**GORDON A. CLEFTON**  
*Senior Project Manager,  
Engineering and Operations Support*

**Subject:** Comments on "Performance-Based Emergency Core Cooling Systems Cladding Acceptance Criteria" (Docket ID NRC-2008-0332) (*Federal Register* Notice 79FR16106)

# **Industry Response to 10CFR50.46c Draft Rule Language**

Figure 4.1: Regulatory Issues Implementation Cost Comparisons

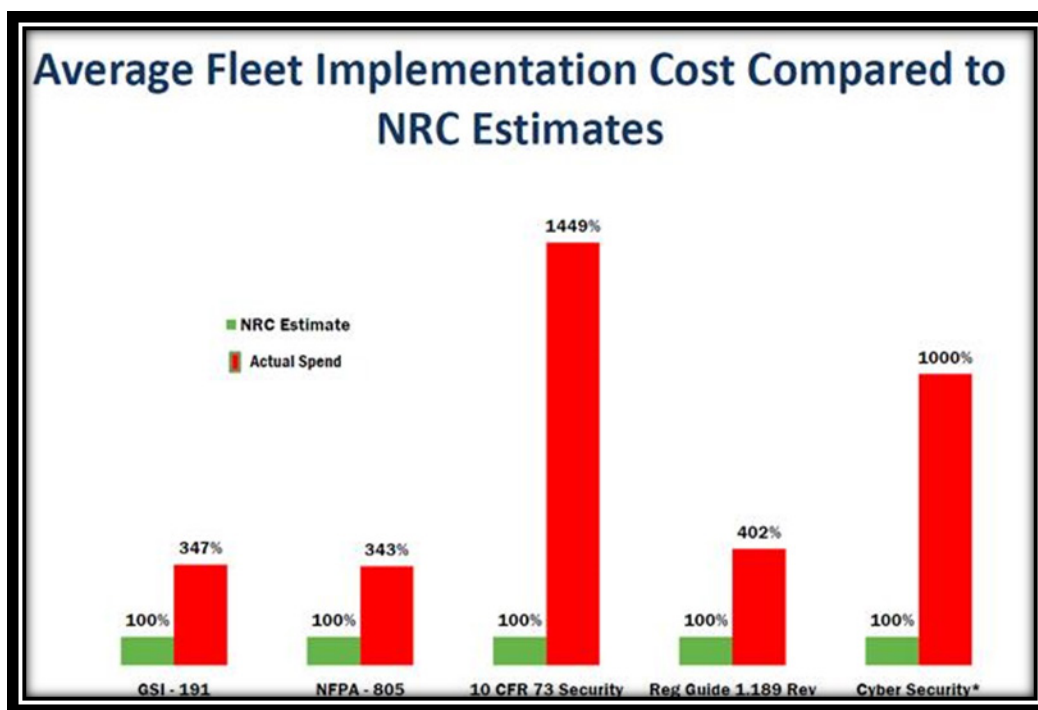
- d. *Please comment on the NRC's cost and benefit estimates in the proposed rule regulatory analysis (ADAMS Accession No. ML12283A188). Specifically, please comment on the vendor hydrogen uptake and LOCA model costs, costs of PQD and breakaway testing, and licensee analysis costs.*

Based on the statement in the regulatory analysis, using the “adequate protection justification” as a basis for not entering the backfit analysis provision per 10 CFR 50.109(a)(4)(ii), industry does not agree that the entire content of the proposed rulemaking meets the backfit requirements. Industry believes NRC should perform a realistic review of the cost of the proposed rule and consider the inaccuracies identified in the regulatory analysis. The overall perception by the industry is that the NRC's cost estimates for industry activities is substantially below current estimates. This perception has been confirmed by both the industry review and in a recent NEI study comparing actual vs. estimated cost for previous regulatory issues (see Figure 4.1), showing a consistent, significant, under estimation of actual costs. Refer to Chapter 5 of this report for the detailed industry comments.

Table A.52: Specific Rule Language Comment 52

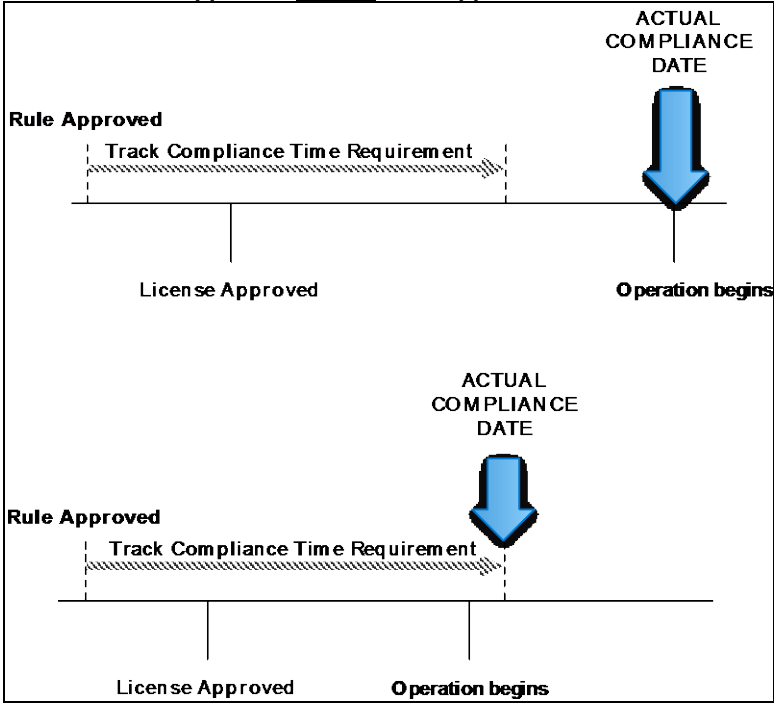
<b>Reference</b>	FRN 79-56, Part II, 10 CFR Parts 50 and 52, Performance-Based Emergency Core Cooling Systems Cladding Acceptance Criteria Proposed Rule, Nuclear Regulatory Commission Federal Register Notice, pages 16106 thru 16146, publication dated March 24, 2014. ( <i>ADAMS Accession No. ML12283A174</i> )
<b>Statement</b>	<p>(o) <i>Implementation</i></p> <p>(9) Combined licenses issued under part 52 of this chapter, before [EFFECTIVE DATE OF RULE] and combined licenses issued after the [EFFECTIVE DATE OF RULE] whose applications were docketed before [EFFECTIVE DATE OF RULE] must comply with this section no later than completion of the first refueling outage after initial fuel load. Until such compliance is achieved, the requirements in § 50.46 continue to apply.</p>
<b>Comment</b>	<p>The NRC is proposing that new reactors per (o)(9) may operate for the initial fuel cycle without meeting the proposed new rule requirements. This language should not require new plants to meet the rule in less time than the Track 1, 2, and 3 compliance requirements if the rule implementation is delayed. It would be possible for the initial cycle to conclude prior to Track timing requirements if rule making is delayed. The following illustrates the comment.</p> <p><b>New or Combined License Approved <u>PRIOR</u> to Rule Approval:</b></p>

<p><b>New or Combined License Approved <u>AFTER</u> Rule Approved:</b></p> 
<i>Rationale</i>	<i>Unclear timing of compliance for new plants during first fuel cycle.</i>
<b>Proposal</b>	<p>Combined licenses issued under Part 52 of this chapter, before [EFFECTIVE DATE OF RULE] and combined licenses issued after the [EFFECTIVE DATE OF RULE] whose applications were docketed before [EFFECTIVE DATE OF RULE] must comply with this section no later than completion of the refueling outage after the first fuel cycle following [EFFECTIVE DATE OF RULE], or 12 months following [EFFECTIVE DATE OF RULE], whichever occurs later. Until such compliance is achieved, the requirements in § 50.46 continue to apply</p>
<i>Justification</i>	<p><i>The change in the implementation date would allow for the COL holders of a Part 52 license to have similar period of time to come into compliance with the proposed changes, similar to timeframes associated with Track 1 Plants from the proposal</i></p>
